**ADDENDUM No. 1**

**CONTRACT NO. B436**

**PLANTWIDE SUPERVISORY CONTROL AND DATA ACQUISITION (SCADA)  
SYSTEM IMPROVEMENTS PROGRAM – WET TRAIN/LINE OPERATIONS**

**July 7, 2026**

|                                                        |  | DRAWING NUMBER: E-008 |

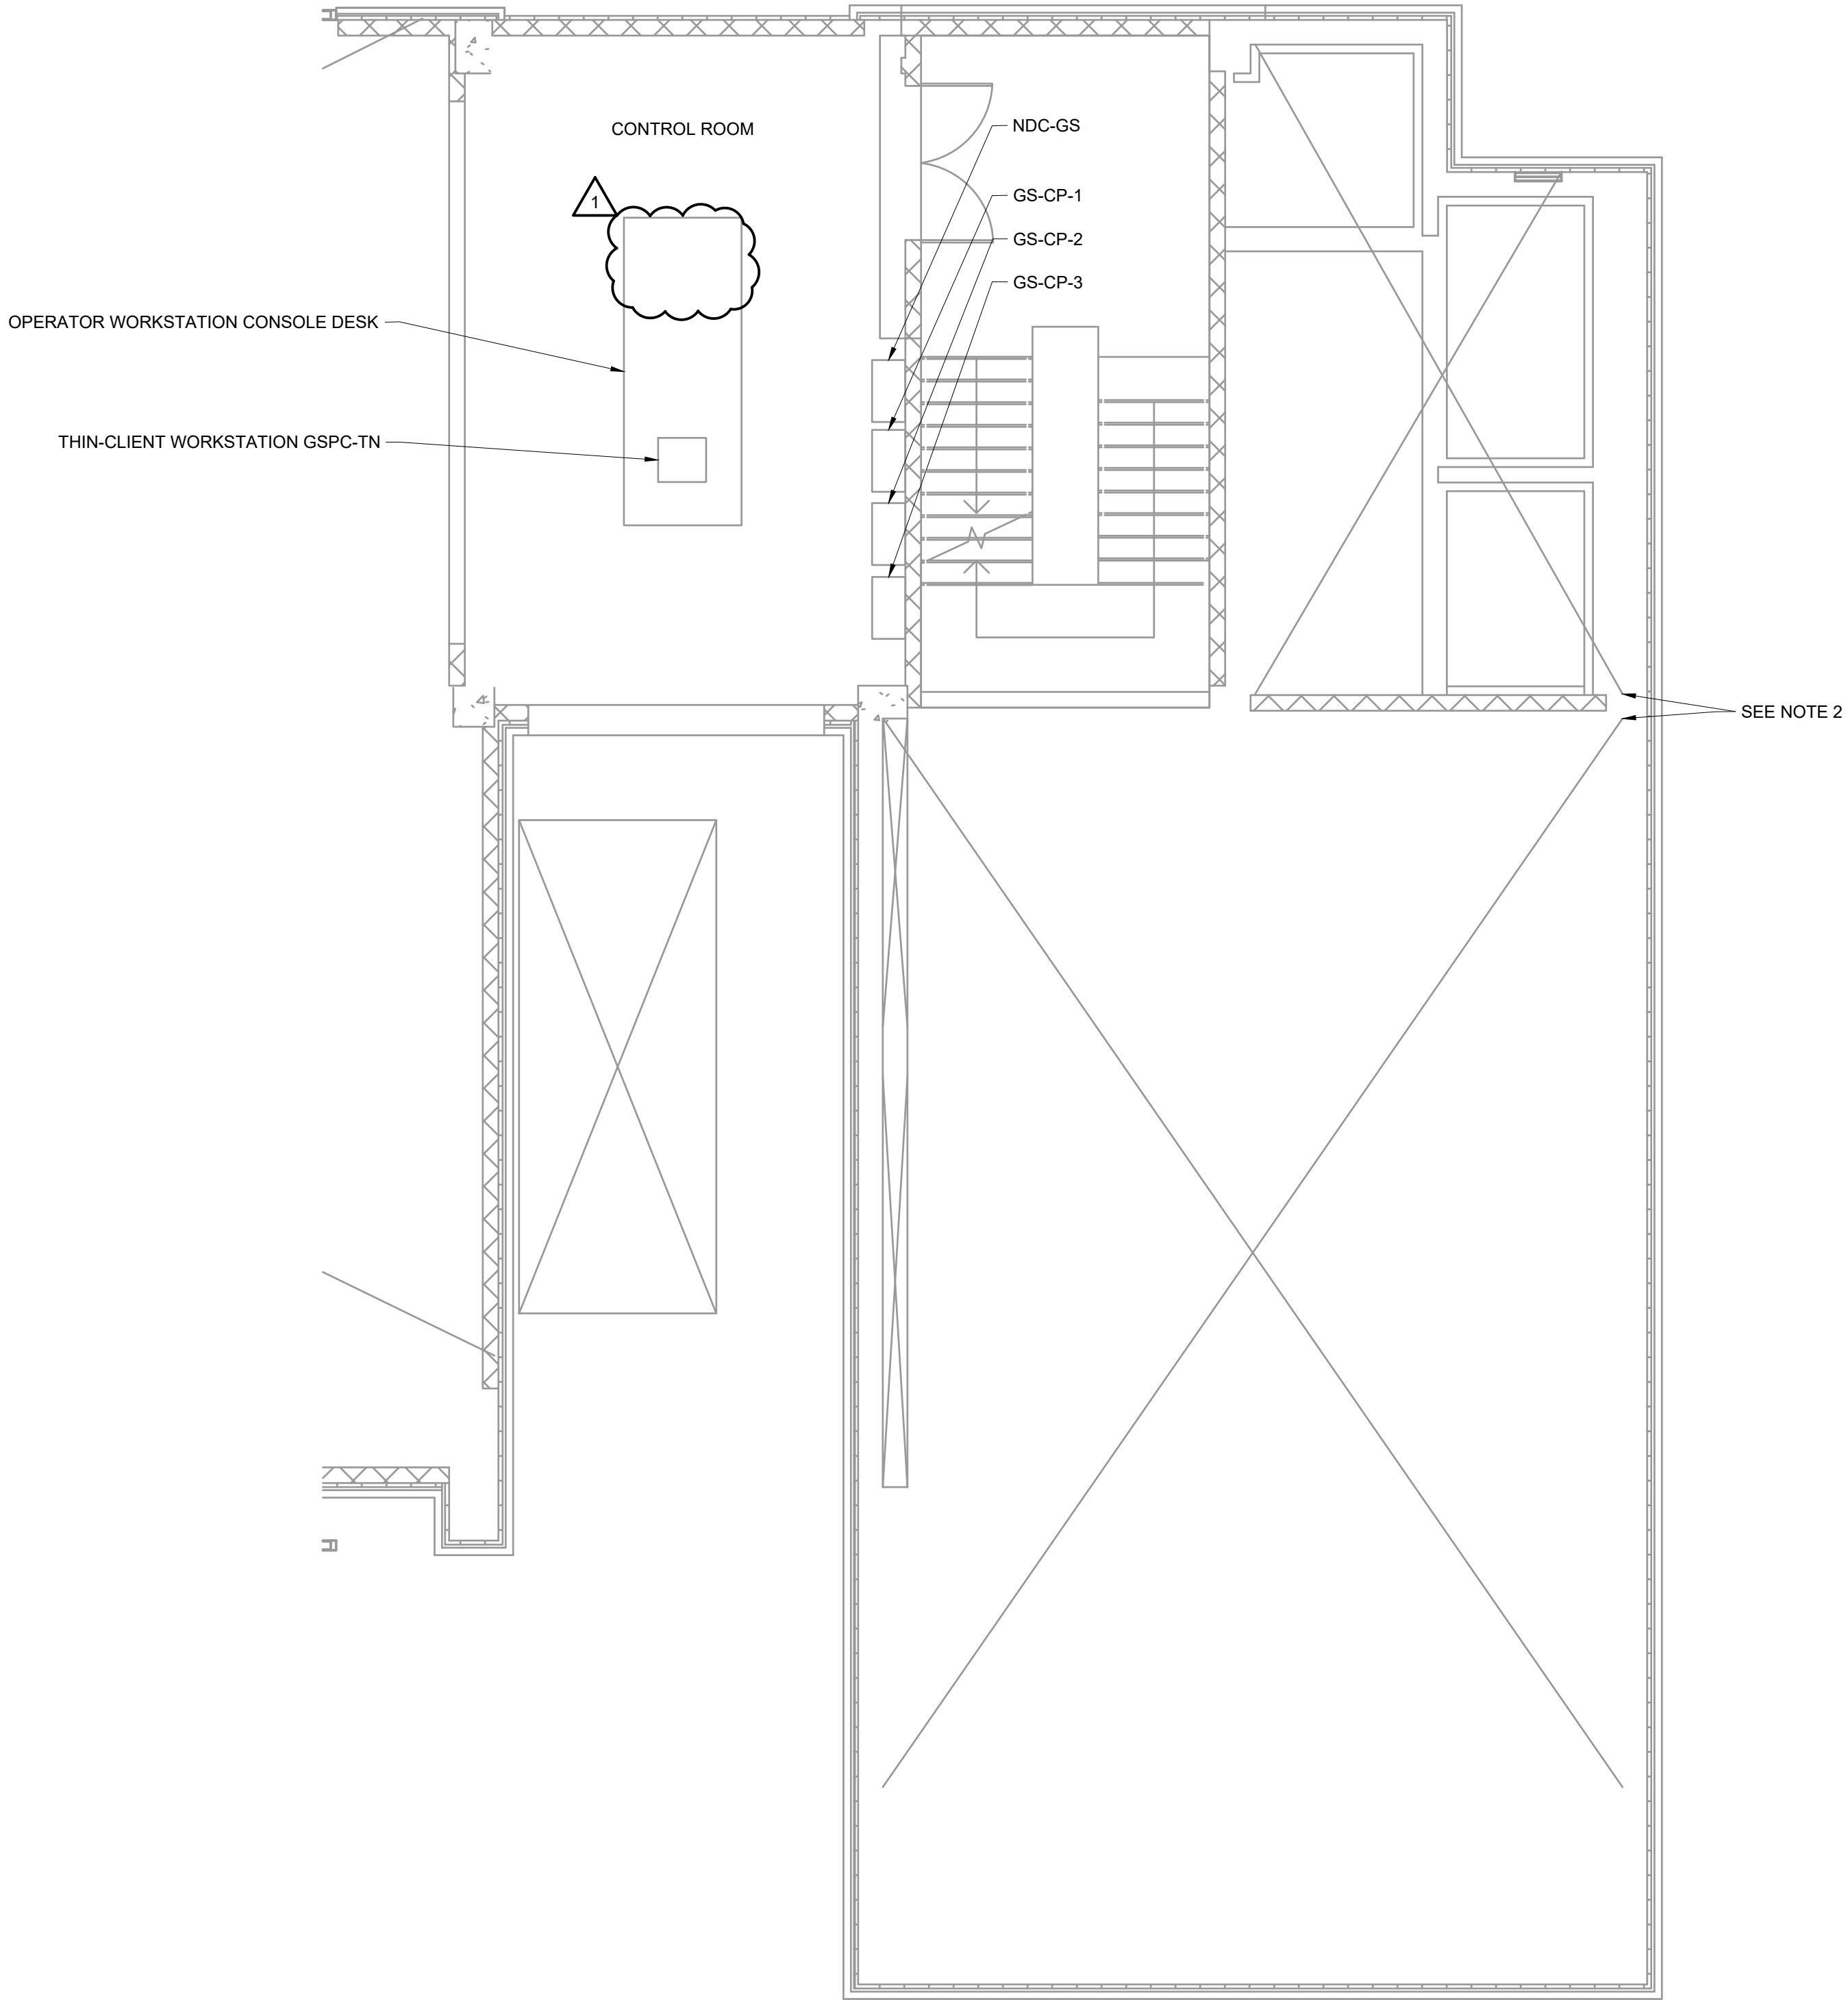
3. Replace drawings included in Bid Documents with Drawings included in Revision 1:
  - a. E-008 – Electrical Cable and Conduit Schedules – Sheet 2
  - b. E-009 – Electrical Cable and Conduit Schedules – Sheet 3

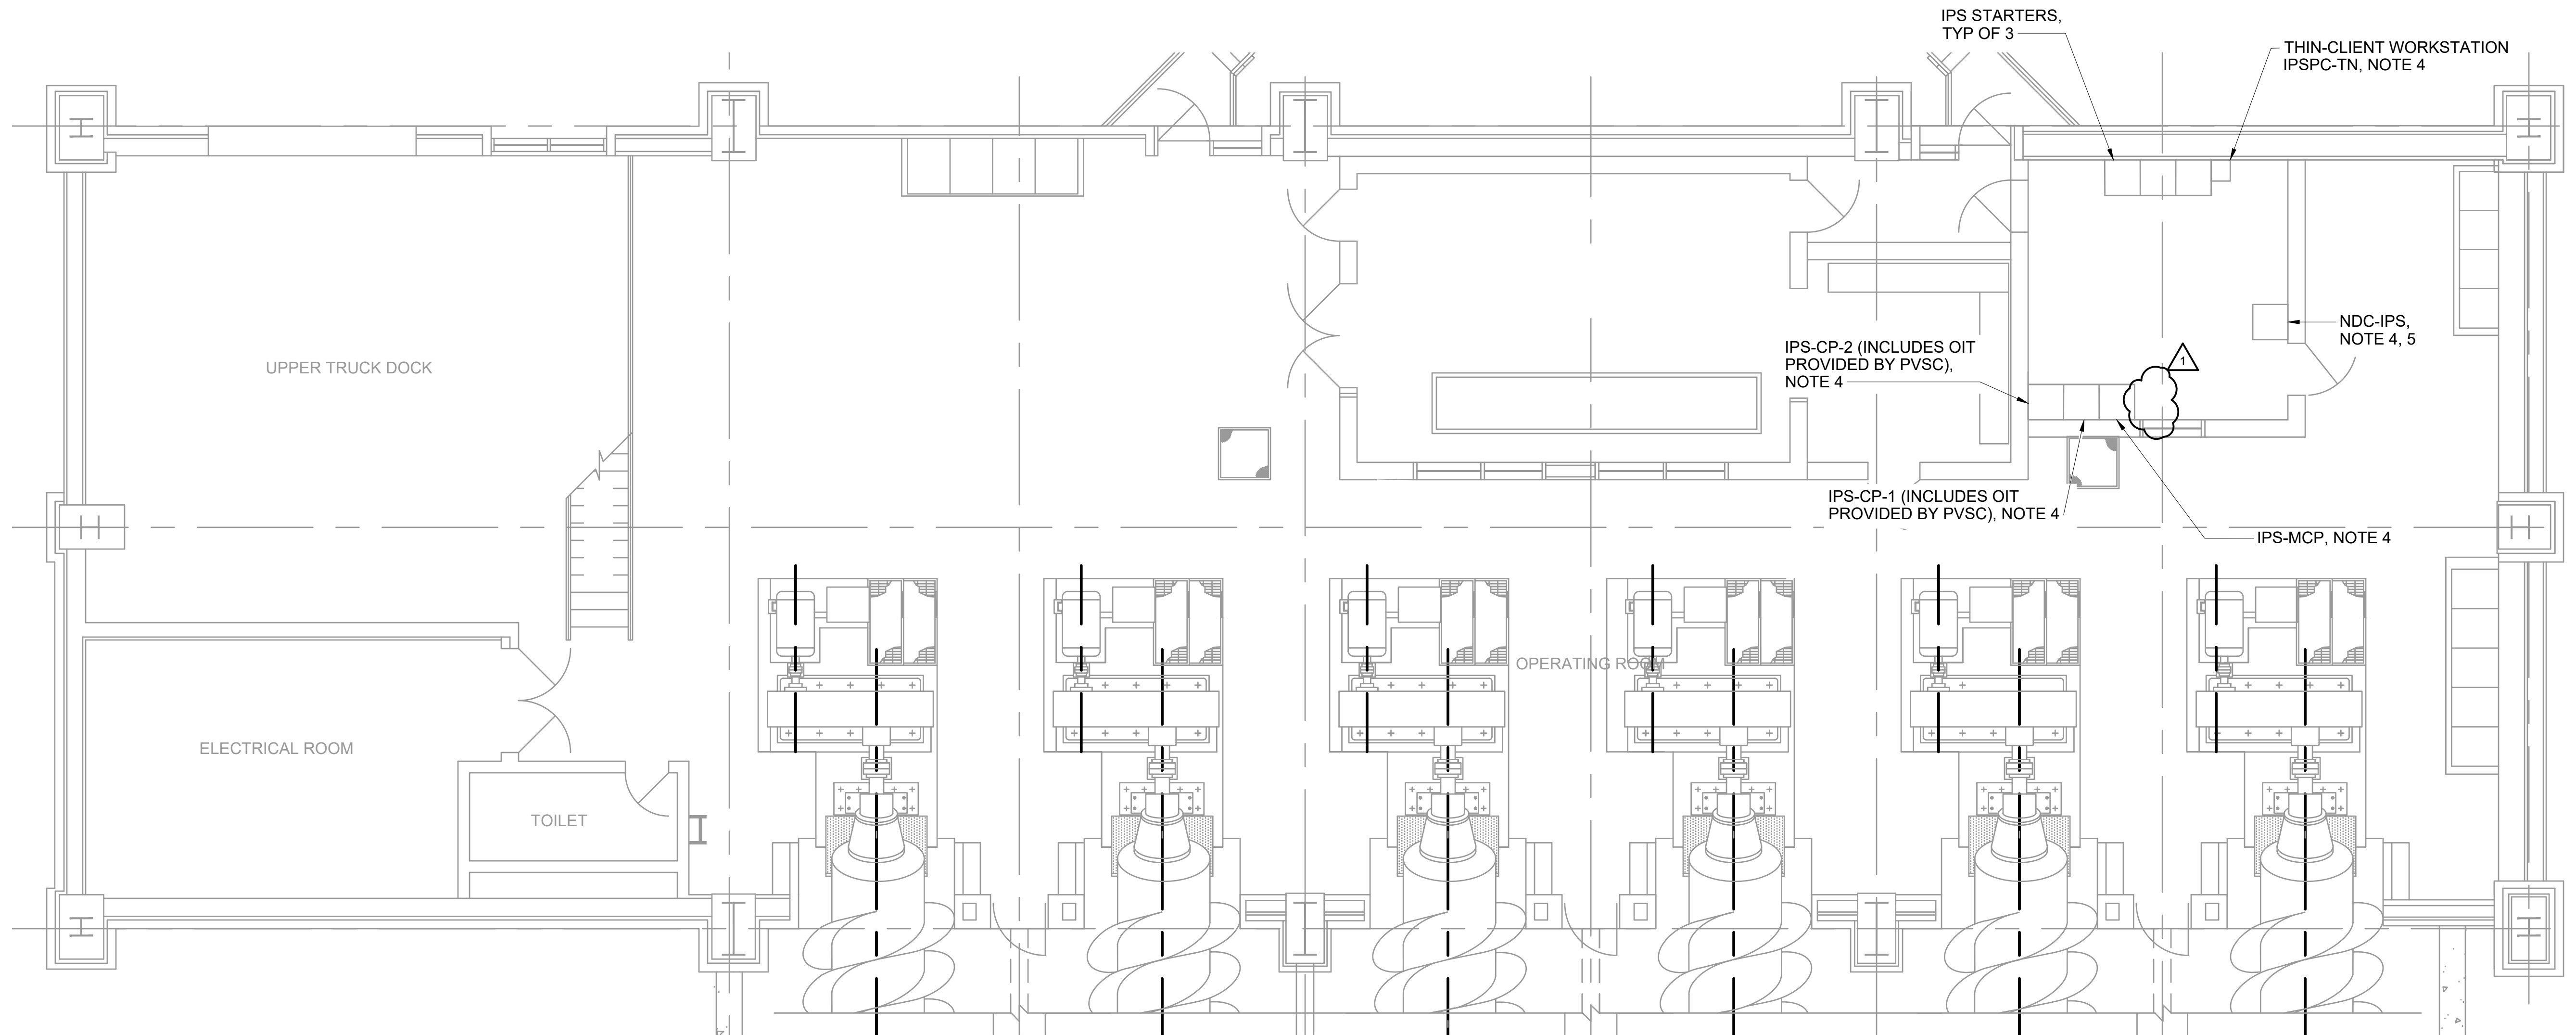
- c. E-101 – Electrical Grit and Screening Second Level Floor Plan
  - d. E-202 – Electrical Influent Pump Station First Floor Plan
  - e. E-301 – Electrical Wet Weather Pump Station First Floor Plan

| DRAWING NUMBER: | E-404     |

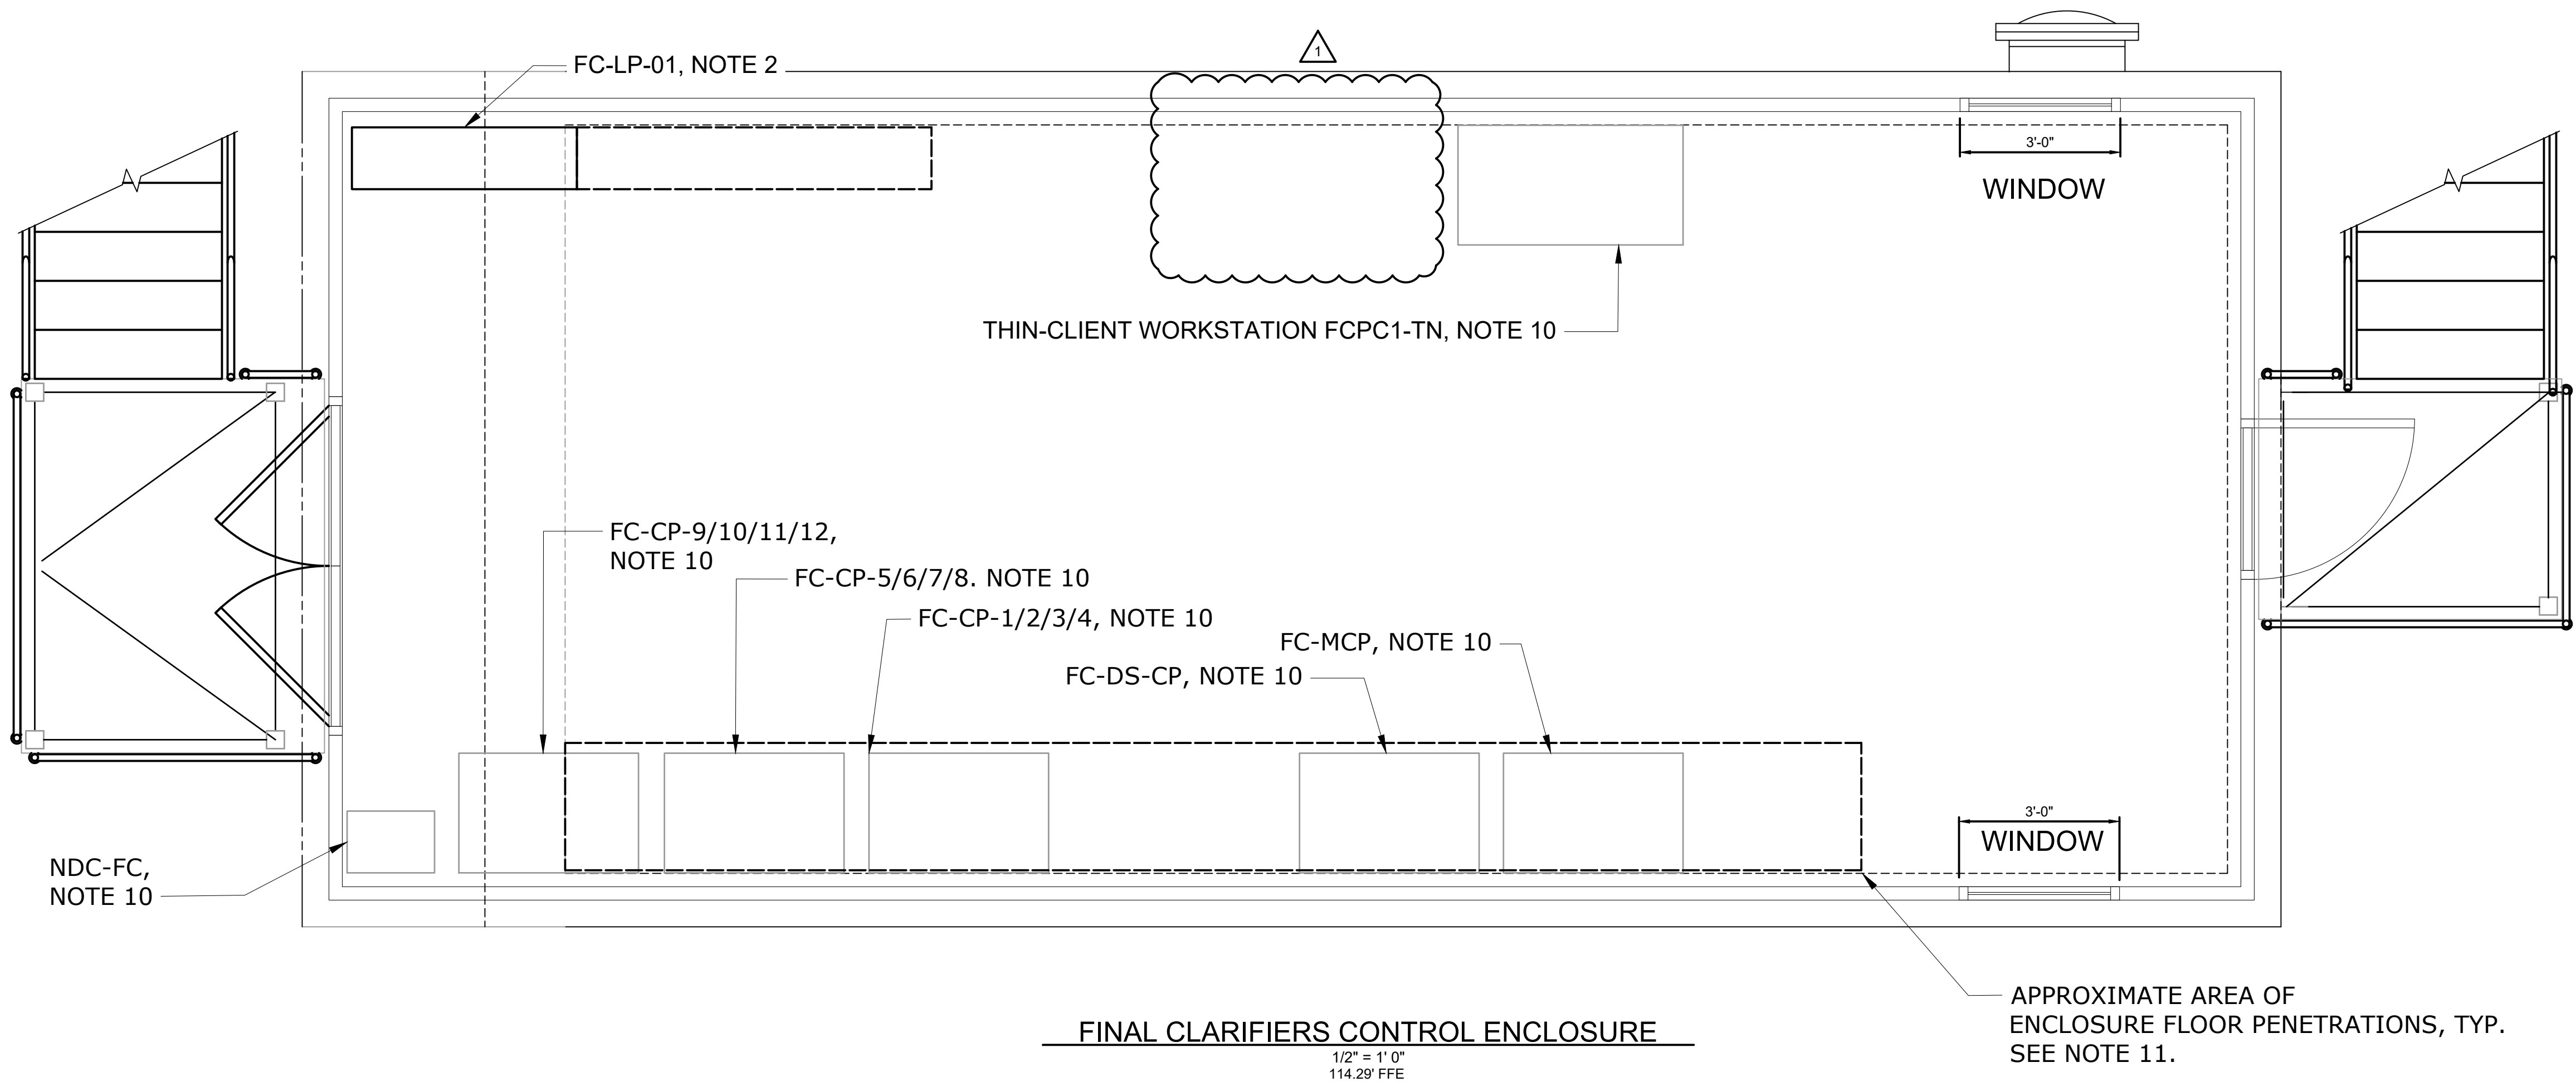
- f. E-404 – Electrical Primary Clarifiers – Dehumidification Building #7 First Floor Plan
  - g. E-504 – Electrical Final Clarifiers Control Enclosure
